S E R V I C E N O T E

8591E Spectrum Analyzer

Counter-Lock Assembly modification to improve marker count stability under certain conditions.

DATE: 09 August 1993

Figure 1. A25 Counter-Lock Assembly

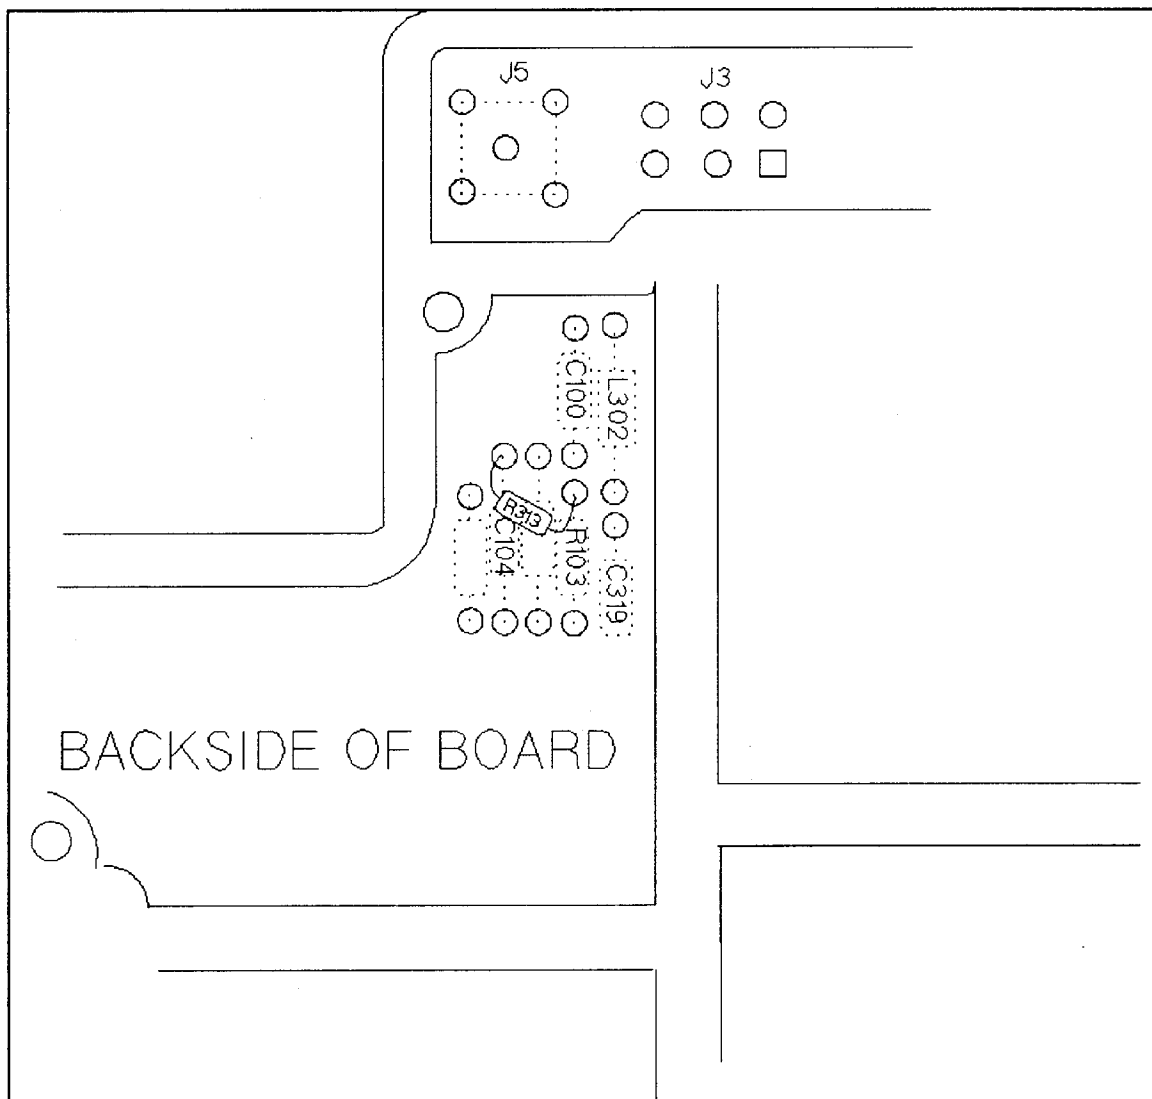
Instruments which have the A25 Counter Lock Assembly with P/N 08591-60053 or 08591-60061 may experience non-stable marker count readings. These non-stable counts are a problem while using marker count on AM modulated signals in wide Resolution BW's. When counting AM modulated signals (like the visual carrier of a TV signal) we have un-wanted modulation (15.7KHz sync rate) on the VIDEO_IF signal being combined with the COUNTER 21.4MHz input signal.

Add a high-pass filter circuit (corner freq of 1.4MHz) to the COUNT IF1(Block M) circuit which blocks the unwanted low frequency modulation signal and allows the 21.4MHz to pass through with very little loss.

1. Reference the A25 Counter-Lock Assembly Removal procedure. The procedure is located in the section of Service Guide labeled “Replacing Major Assemblies” on pages 7-41 and 7-42.
2. Remove the screw securing the two halves of the casting. Separate the casting halves and place the assembly bottom side up on the work surface.
3. Refer to Figure 1. for the location of R103 and remove R103. Install C321 in place of R103 but do not solder at this time. Install R313 as shown in Figure 1. One lead will share a hole with C321 (just installed). The other lead will share a hole with C104 as shown.
4. Apply the label (08591-60073) over the old board number.
5. Apply a label (08591-60073) onto the rear panel for future reference.
